## ENGINEERING CHANGE NOTICE

1. ECN **603877**

Description of Work for Vadose Borings in Support of 200-UP-2 Unit

WHC-SD-EN-AP-147

Figure 2e. Proposed Borehole Location Map 299-W23-231.

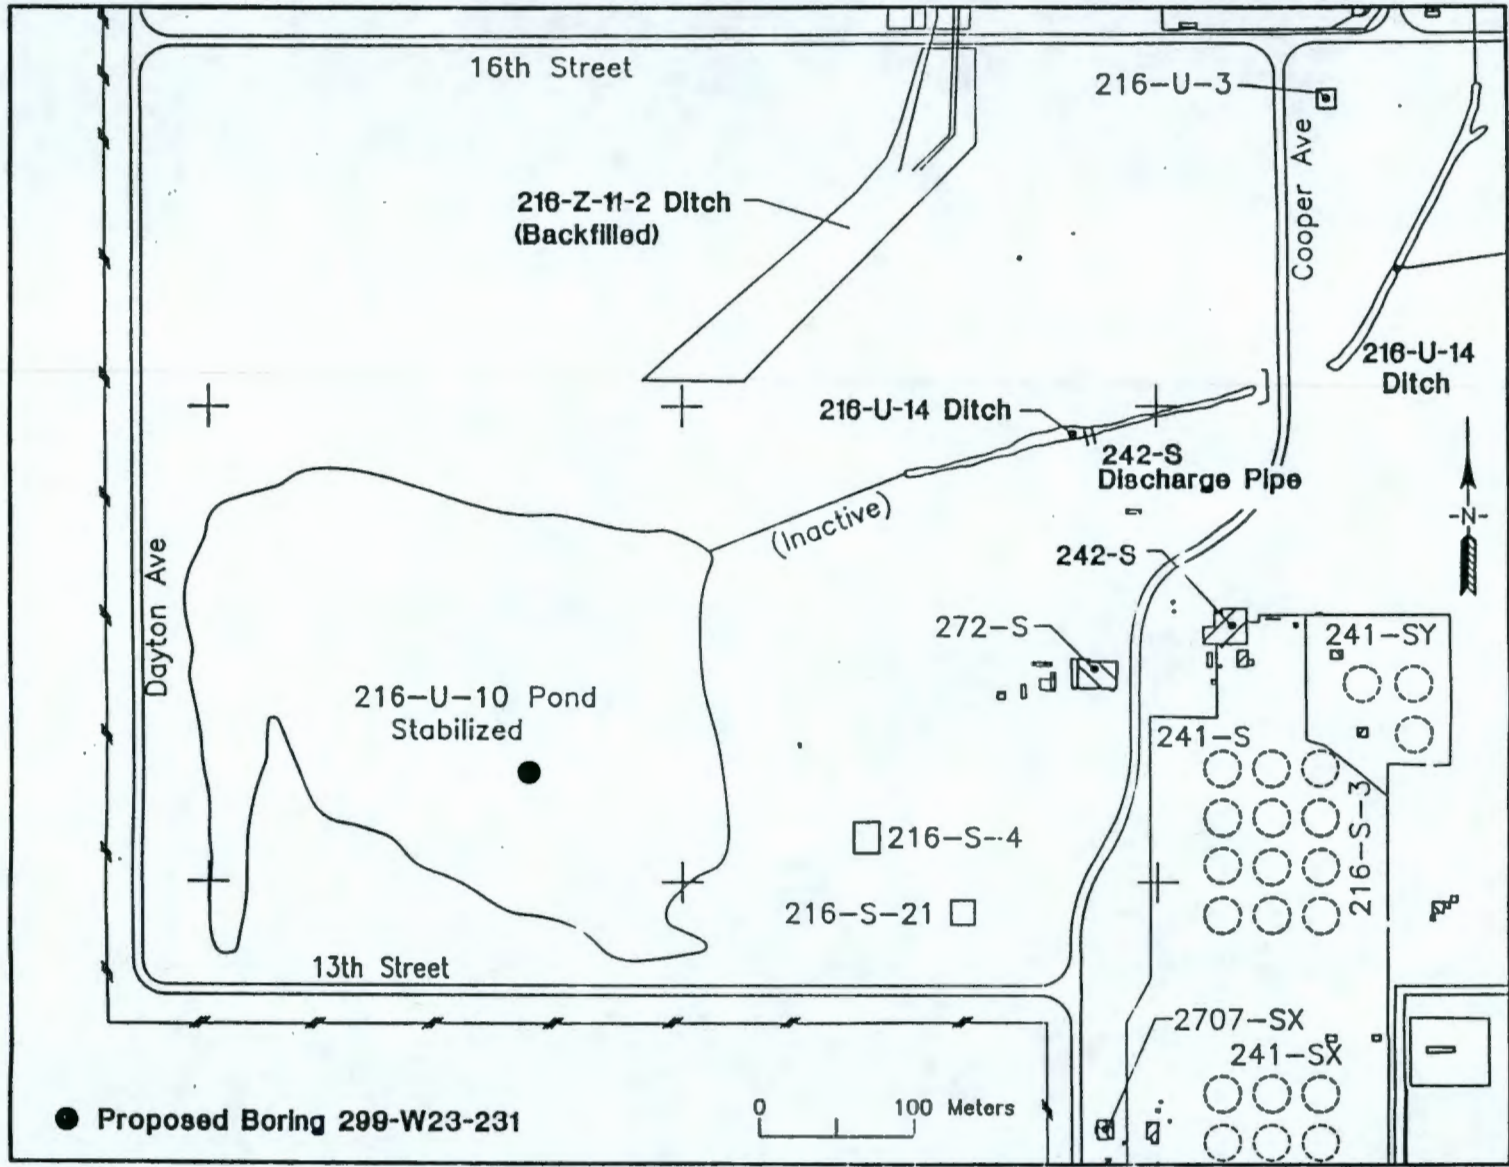
Boring 299-W23-231 will be drilled near the southeast corner of the U-10 Pond to the top of the caliche layer (Figure 2e). The boring will be used to characterize the vertical extent of contamination. The majority of contaminants should occur at the former pond bottom.

2. Section 3.2, third paragraph, "Borings 299-W19-94..." change to "Borings 299-W23-231, 299-W19-94..."
3. Section 3.2, third paragraph, first bullet, "...below the bottom of the crib or french drain.." change to " below the bottom of the crib, pond bottom or french drain.."
4. Section 5.0, table with well numbers and drilling dates; add to bottom of table "299-W23-231 Early Mar. 1994 - Mid Apr. 1994"
5. Page 22, Insert Figure 2e, attached.
6. Page 32, Table 4. Proposed Sampling Intervals (two page table).
